AGENDA
CITY OF GLENWOOD SPRINGS
Planning and Zoning Commission
Regular Meeting
MAY 5, 2020
Council Chambers, First Floor
101 W. 8TH STREET
6:00 PM

MINUTES
City of Glenwood Springs
Planning and Zoning Commission
Regular Meeting
February 25, 2020
Council Chambers, First Floor, City Hall
101 W. 8th Street
6:00PM

Date: April 28, 2020
To: Planning and Zoning Commission
From: Gretchen Ricehill, Asst. Director
Subject: #11-20 Code Text Amendments–Title 070
Glenwood Springs Municipal Code

Figure 5: Directional Distribution of Project Traffic - Blake Ave. Gate Remains Closed

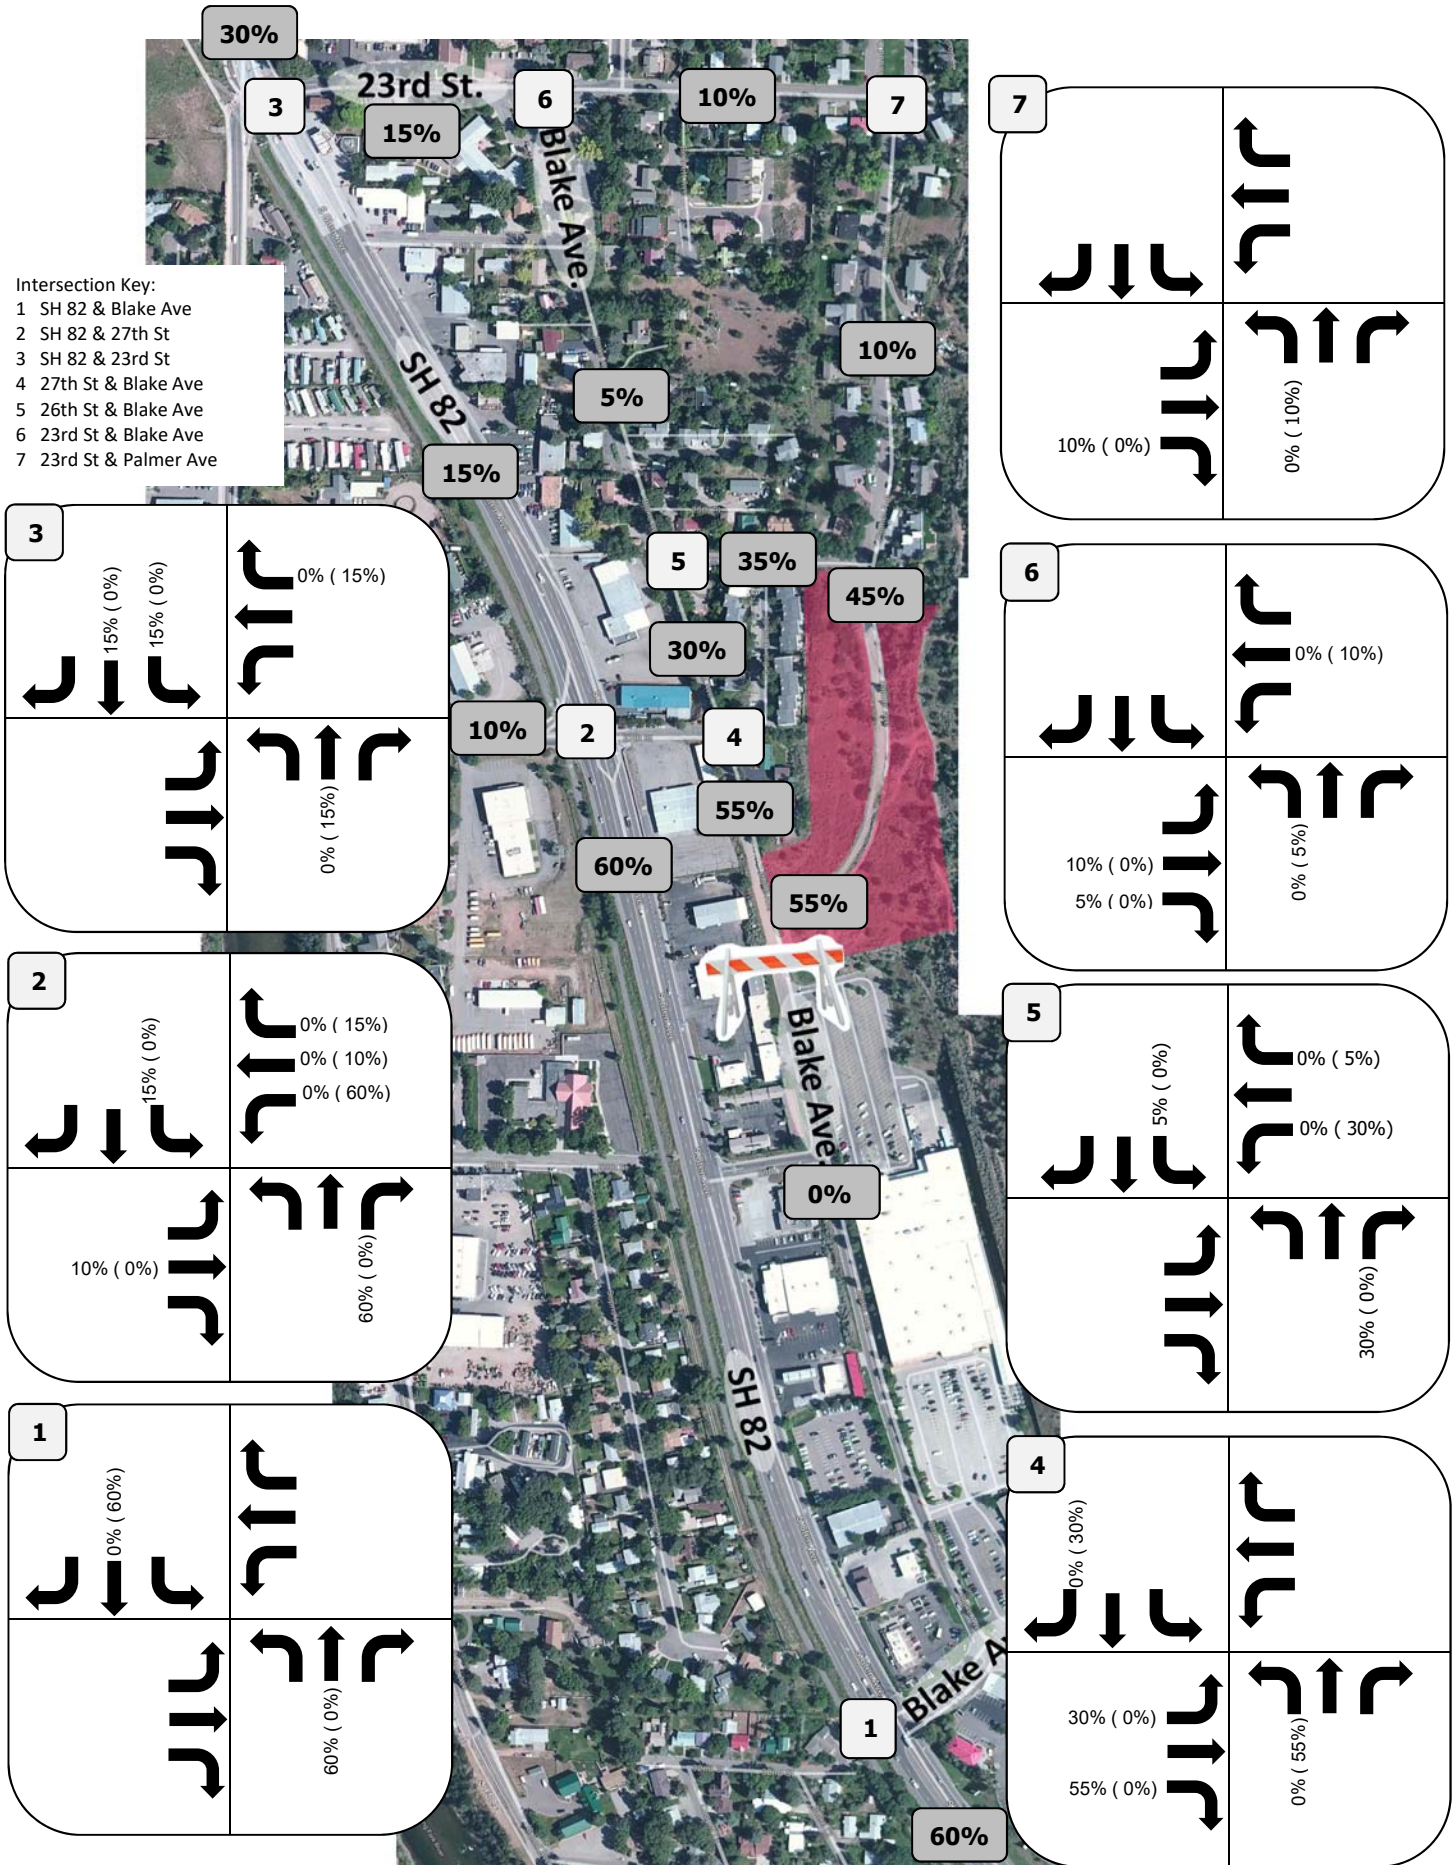
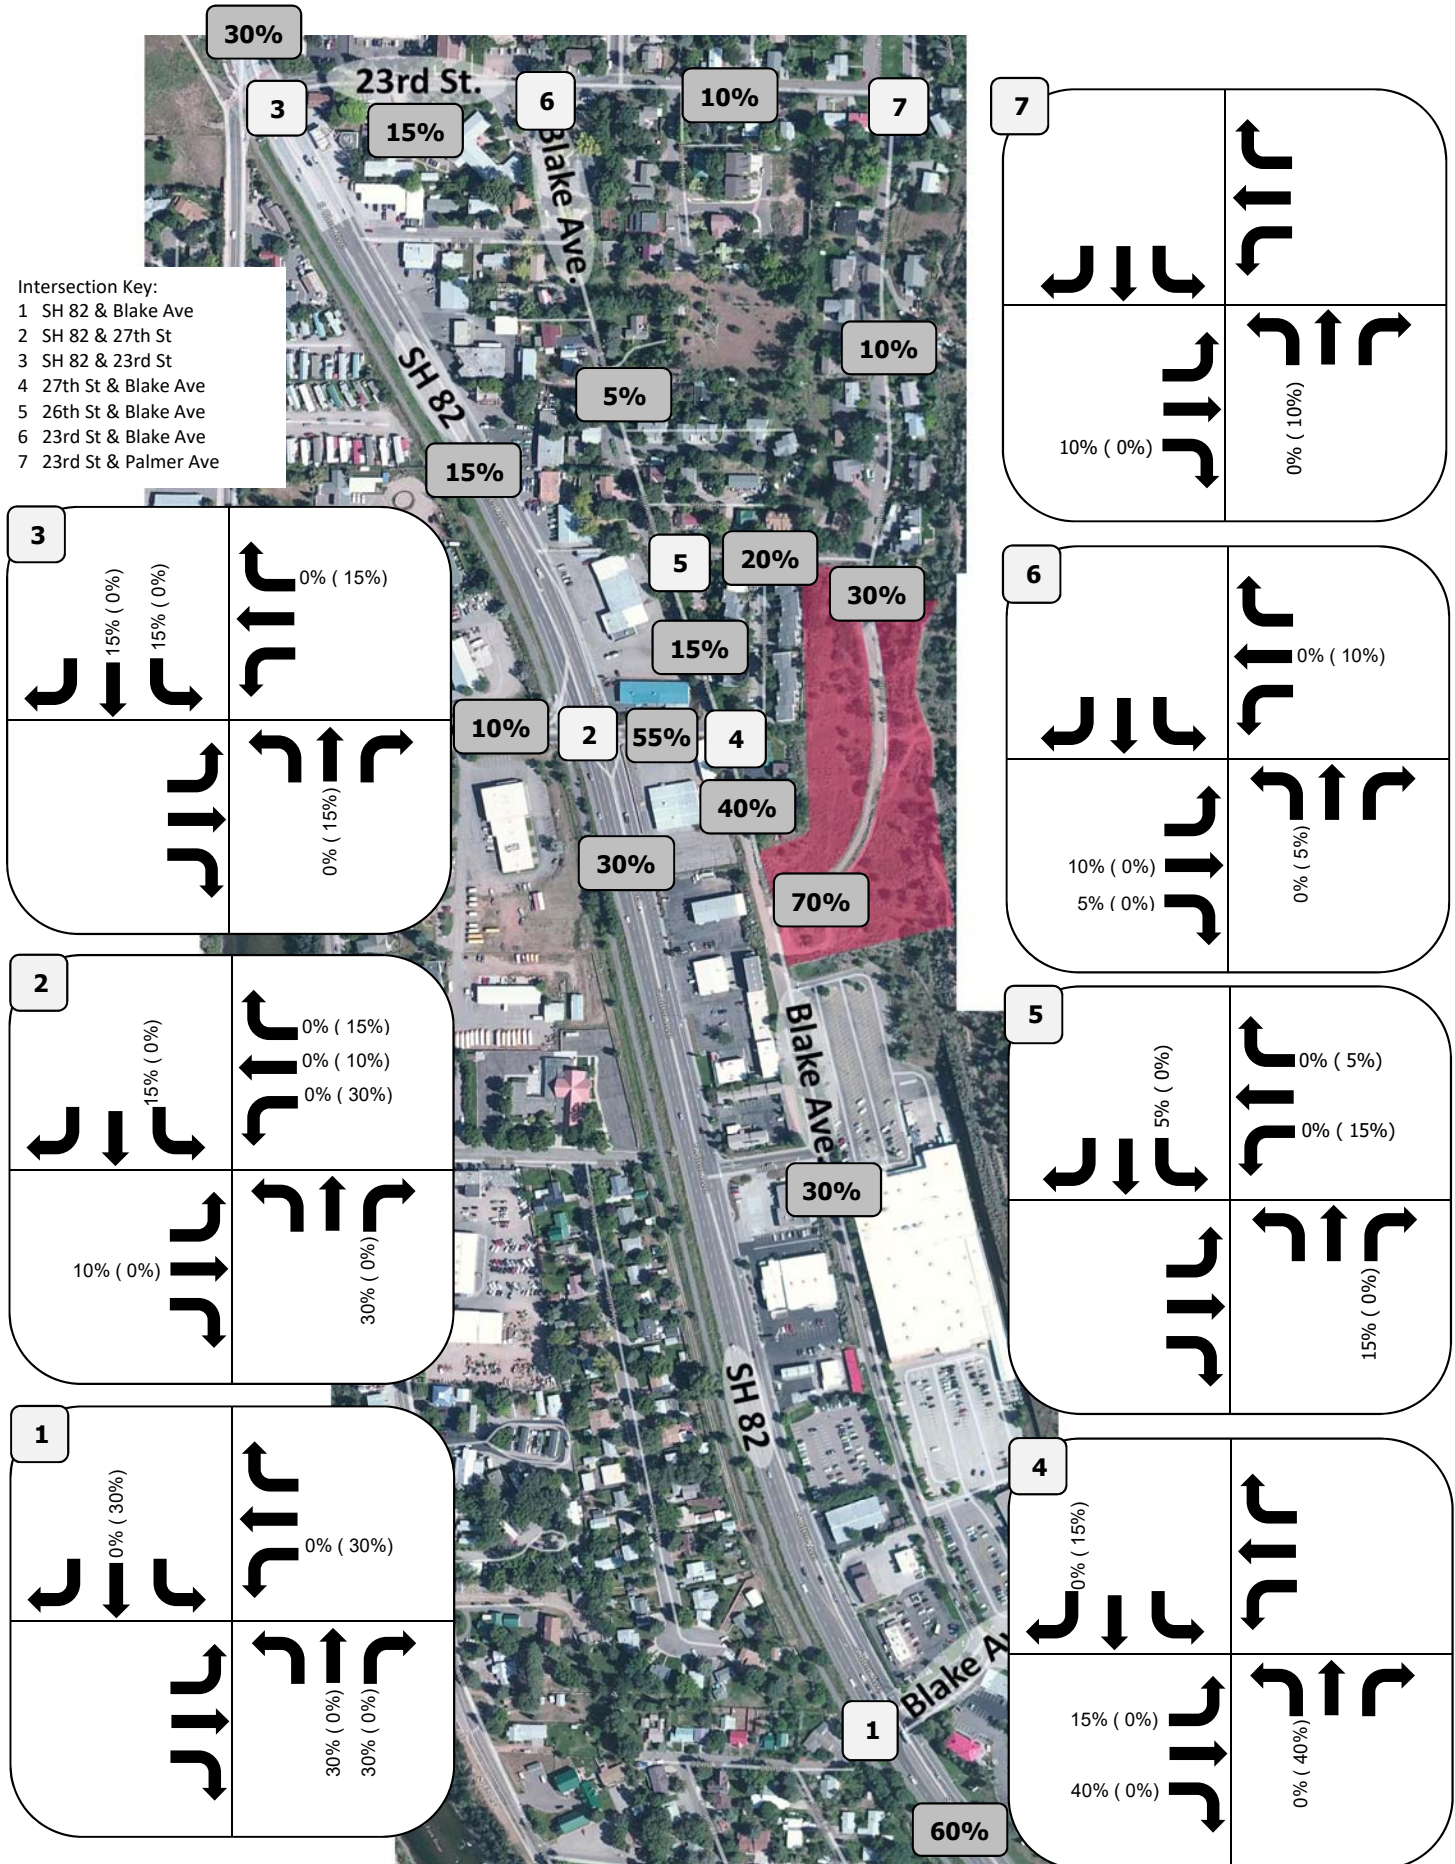
17. Figures 5 and 6: 30% is added to intersection 1 in the gate open scenario (figure 6). This brings the total directional distribution to 130%.
